RFI59

Project: COOLEY LABORATORY RENOVATION
Job: 3146 COOLEY LAB, PPA# 10-0023
Customer: STOFMT MSU BOZEMAN

Item: HELICAL PIER AT ARC ENTRANCE

Reference: 2/S2.7

SKETCH A

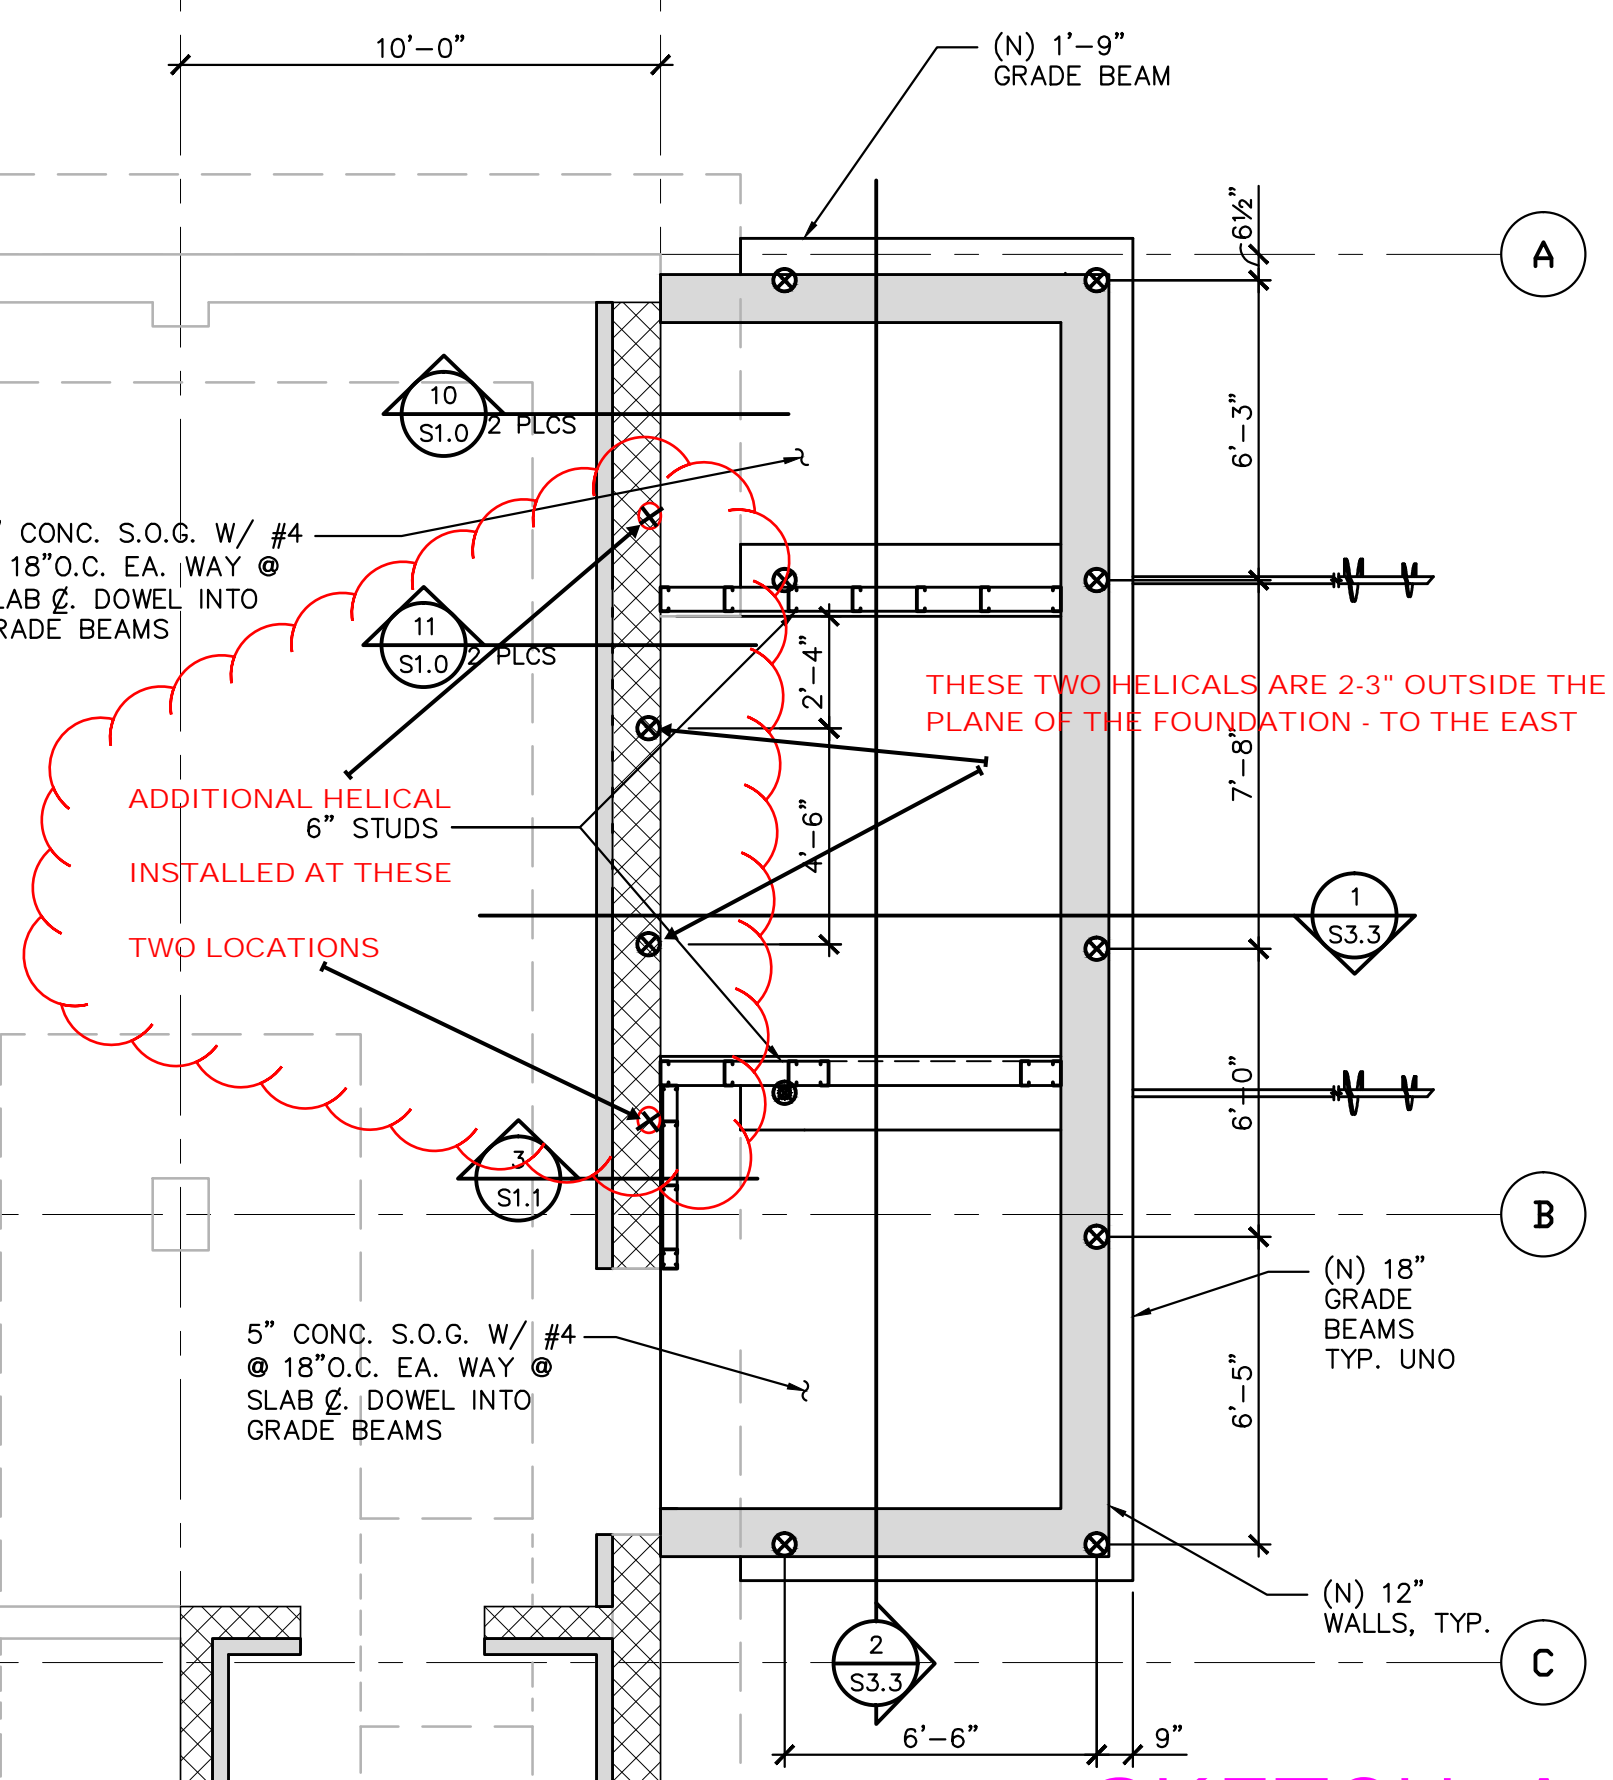
The two helical piers shown within the elevator pit have been installed. Both of the underpinning brackets are skewed within the plane of the elevator pit. The counterbalance weights and cab rails would be in conflict. To resolve the situation we would propose to remove the vertical leg on the Chance Bracket and push the bracket to the west until it is out of conflict approximately 2 to 3 inches.

SEE FIELD CONSTRUCTION REPORT DATED NOV 29TH
(ITEM #8) FOR NOTES ON THE INSTALLED PIERS.
AEGIS ENGINEERING DOES NOT HAVE A PROBLEM WITH
THE PROPOSED REALIGNMENT OF THE HELICAL PIERS
PROVIDED THAT THE HELICAL PIER MANUFACTURER
APPROVES THE CHANGES.

SKETCH B

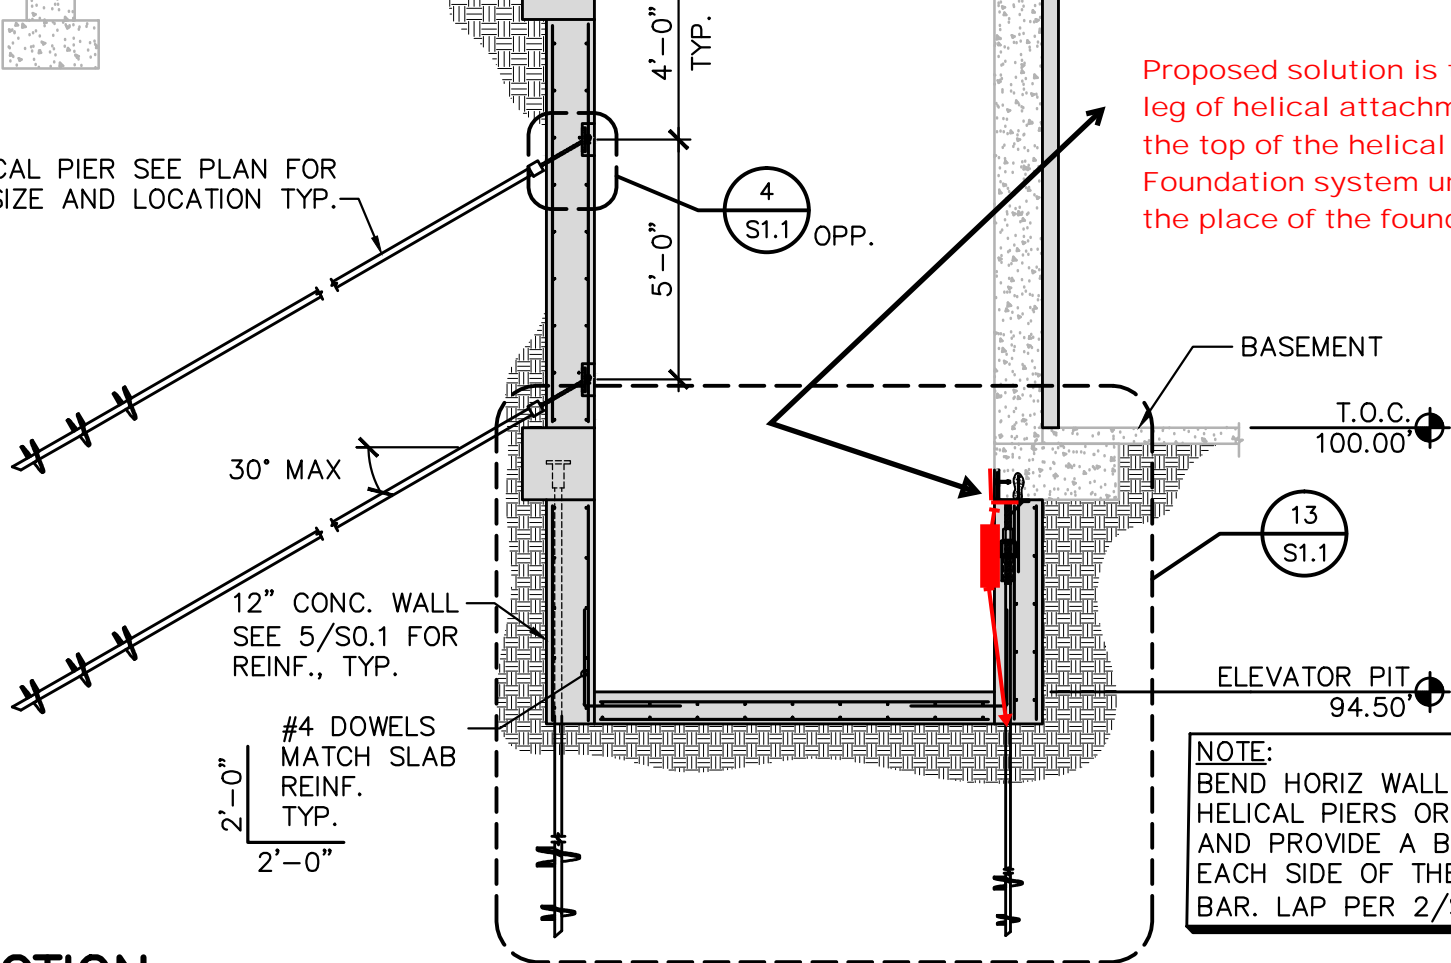
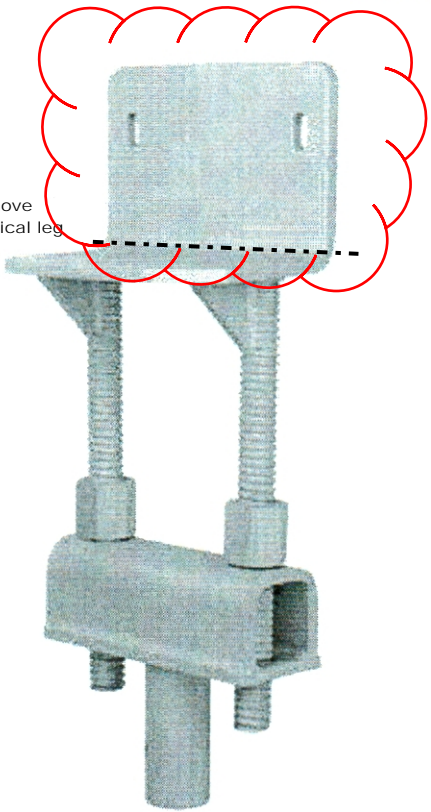
Proposed solution is to cut top leg of helical attachment and jack the top of the helical under the Foundation system until it is within the place of the foundation.

Remove
Vertical leg
